# Clarke St pop up park and share path

## – BikeWest Feedback

### Executive Summary

Figure 1: Widths for Shared Paths

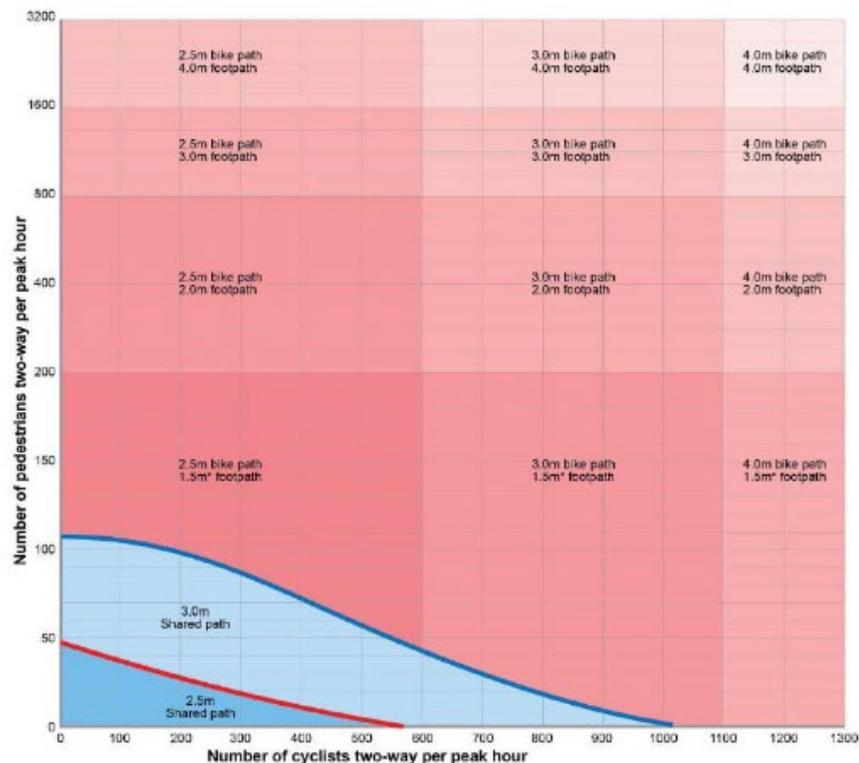
According to Austroads Guide to Road Design Part 6A: Paths for Walking and Cycling p28, if the space is used by more than 100 pedestrians per hour during peak times then there should be a separate dedicated bicycle path (Figure 1). If the park proves popular this is almost certain to be the case during the summer months.
